Access Compliance Report

Public Rights-of-Way

Intersection ID: 18794	Main Street: RANDOLPH_RD	Cross Street: REMBRANDT_CR	Location: SE
ADA ID: 0E38620B06A0	Ramp Type: Perp	Initial Pass/Fail: Fail	Overall Compliance: No
		Severity Score: 12.5

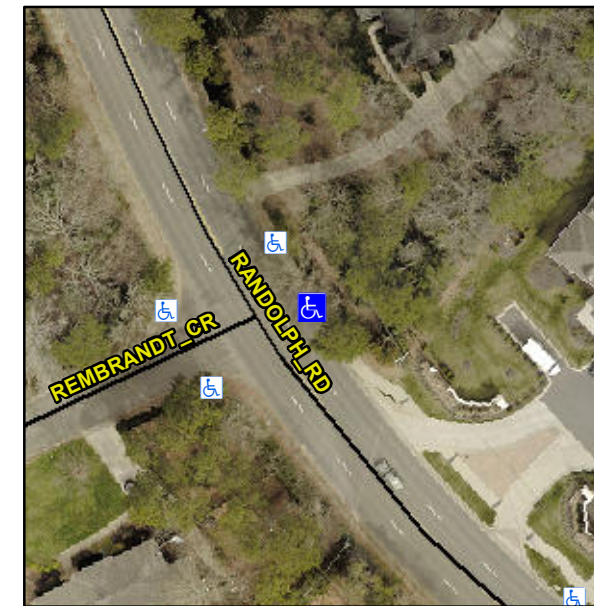
Not Found, R304.2.2

Compliance	Description	Data	Compliance	Description	Data
N/A	Ramp Length (in)	71.0	No	Ramp Slope (%)	8.6
Yes	Ramp Width (in)	48.0	Yes	Ramp XSlope (%)	1.3
N/A	Flare Type LT	N/A	N/A	Flare Type RT	N/A
N/A	Flare Slope LT (%)	N/A	N/A	Flare Slope RT (%)	N/A
N/A	Flare Traversable LT?	N/A	N/A	Flare Traversable RT?	N/A
N/A	Landing Length (in)	N/A	N/A	DWS Provided?	N/A
N/A	Landing Width (in)	N/A	N/A	DWS Contrast?	N/A
N/A	Landing Slope (%)	N/A	N/A	DWS Length (in)	N/A
N/A	Landing X Slope (%)	N/A	N/A	DWS Full Width?	N/A
N/A	Landing Curb? (Y/N)	N/A	N/A	DWS Offset (in)	N/A
N/A	Shared Landing?	N/A			
N/A	Gutter Ponding?	N/A	N/A	Gutter Slope (%)	N/A
N/A	Gutter Lip Ht (in)	N/A	N/A	Gutter X Slope (%)	N/A
N/A	Painted X Walk1?	No	N/A	Painted X Walk2?	N/A
	X Walk 1 Direction	To W		X Walk 2 Direction	N/A
N/A	X Walk 1 Width (in)	N/A	N/A	X Walk 2 Width (in)	N/A
	X Walk 1 Slope (%)	5.7		X Walk 2 Slope (%)	N/A
	X Walk 1 X Slope (%)	2.3		X Walk 2 X Slope (%)	N/A

Remove & Replace Entire Ramp.
